Response to Reviewer #2

General comments
The manuscript discusses compound flooding using an analytical model after validating the model with an idealized hydrodynamic model. The authors conducted sensitivity tests and investigated what the important factors for compound flooding are. The methods are appropriate and the results are interesting, but my concern with the manuscript is seemingly lack of novelty. The analytical model has already been developed and the results are mostly in line with the past literature. Some results are new, but they don't look like scientifically novel.

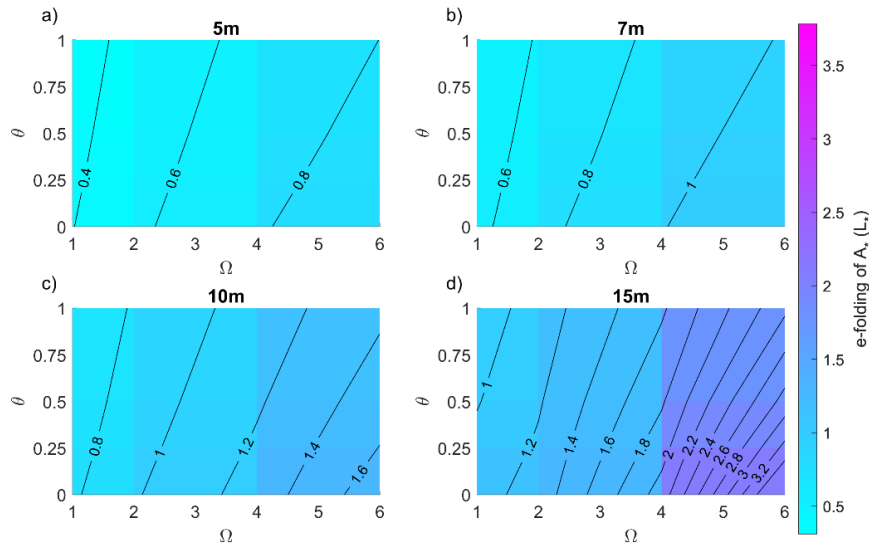
394 Figure 7
It is hard to see the contour lines and labels. Use a different color or use a different colormap. A monotonic colormap may help. Also, I am a bit confused with the figures as θ and Ω only have 4 numbers in table 1, but the figure looks like there are more data. Did you use shading color (e.g shading interp on MATLAB)? If so, it is better to use flat (no-shading). Please clarify.
We attempted different colormaps and chose a light color that would help to see the contour lines better. There are four values for θ and Ω. We also included more time scales ($\Omega = 1, 2, 3, 4, 5,$ and 6), corresponding to the surge primary period of 12hr, 24, 36, 48, 60, and 72hr, and the results are similar as plotted. Thus, and to have less number of combinations, we chose 4 values for Ω to plot. Shading interp is also necessary as you can see the following plot doesn't have shading (flat shad) and the colors don't follow the contour lines. We also used the same colormap in Figures 9 and 10 for consistency.
